Author comments

Ref: nhess-2017-99

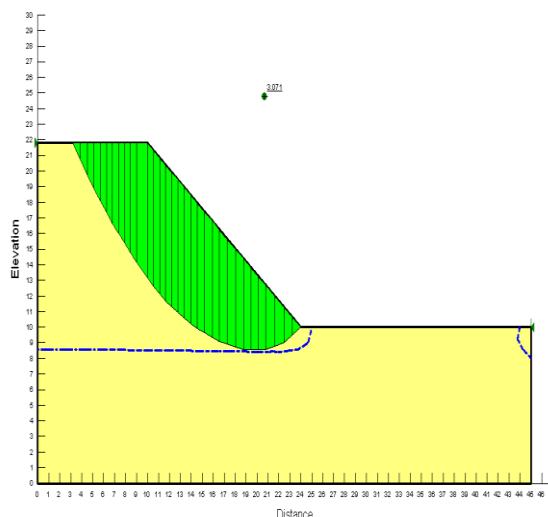
4. Concerning the stability analyses, are they conducted considering an infinite slope schematization (as written in page 3, line 6 and page 4, lines 19-20) or a boundary value problem in 2D (as one may infer from the fact they use the Geo-studio software)? In the latter case, what's the geometry of the considered slope(s)? The Authors do not provide any detail on the schematization of the slopes and on the shape and position of the sliding surfaces. What's the meaning of the 30 factors of safety computed (Table2) in relation to the slopes and landslides present in the study area?

We conducted stability analyses considering a boundary value problem in 2D, the geometry of the considered slope of group 12 is illustrated as below. As can be seen, the schematization of the slopes and on the shape and position of the sliding surfaces can be clearly identified. The 30 safety factors were computed and utilized as training samples by ANN, then the trained ANN could be used to figure out the relationship between the slopes and potential landslides in the study area.
